**CITY OF LA VISTA
MAYOR AND CITY COUNCIL REPORT
SEPTEMBER 18, 2018 AGENDA**

Subject:	Type:	Submitted By:
APPLICATION FOR PUD SITE PLAN – LOT 1, ROTELLA’S FIRST ADDITION, LOTS 4, 5, 6, 15, 16, 17, AND 28A OAKDALE PARK, AND TAX LOT 8A2 (108 TH ST & HARRISON ST)	◆ RESOLUTION ◆ ORDINANCE RECEIVE/FILE	CHRISTOPHER SOLBERG CITY PLANNER

RE: Rotella's Italian Bakery
Site Development Plan
Proposed Planned Unit Development (PUD) Site Plan - Initial Review

RE: Rotella's Italian Bakery
Site Development Plan
Proposed Planned Unit Development (PUD) Site Plan – 2nd Review

3D - CONVEYORS AT ROTELLA'S OFFICE MEZZ.

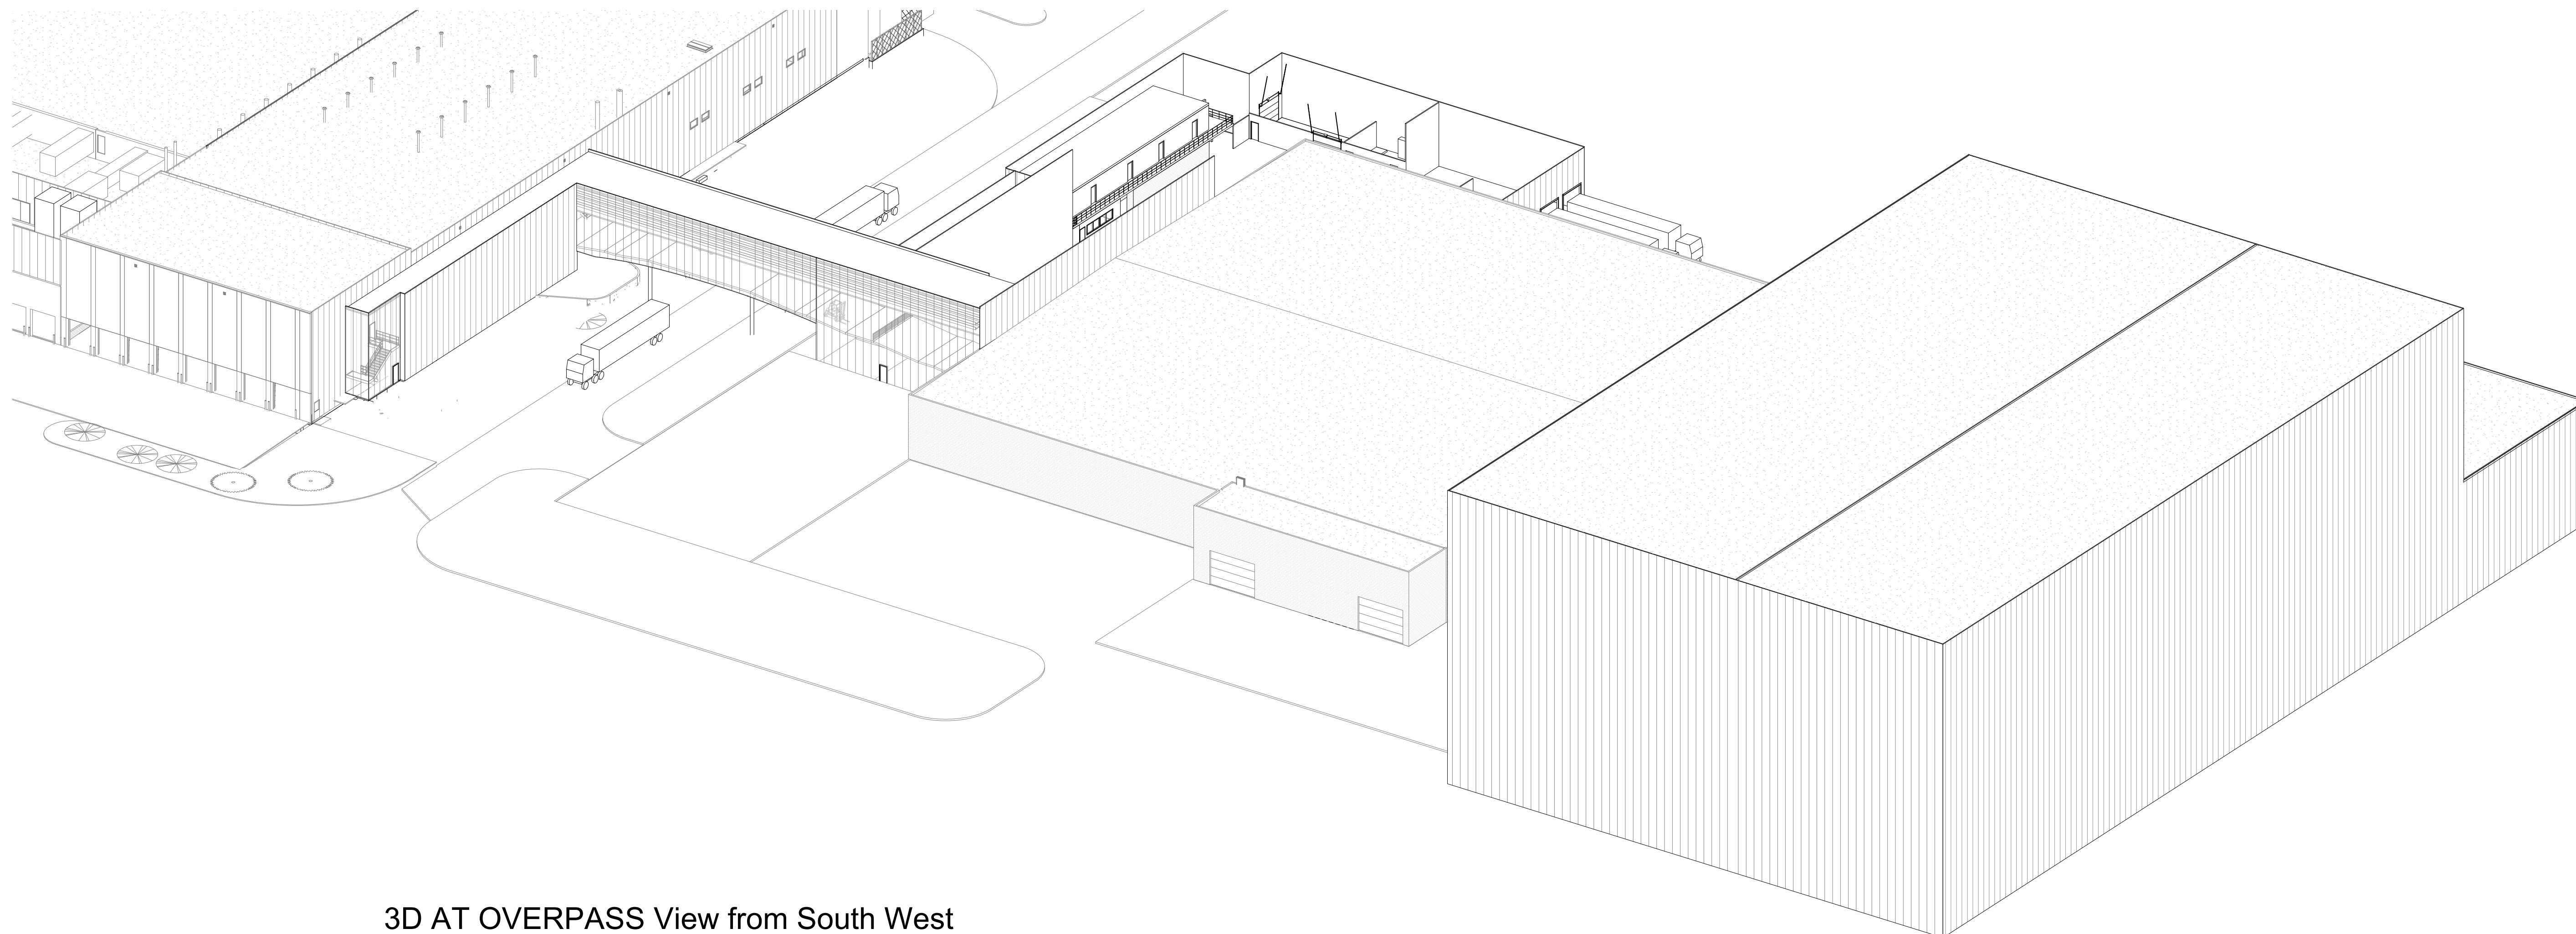
3. A recent conversation with a consultant working for the applicant indicated the possibility of the need to lower Gertrude Street to accommodate the proposed skywalk connection between the Main Plant and the former McKesson Building. If that is being proposed, then that needs to be addressed with this submittal. It is recommended that lowering of this road be avoided, if at all possible.

b. **Comment:** If Gertrude street needs to be lowered to accommodate the future skywalk, then that needs to be addressed with this submittal. It is recommended that lowering the road be avoided if at all possible.
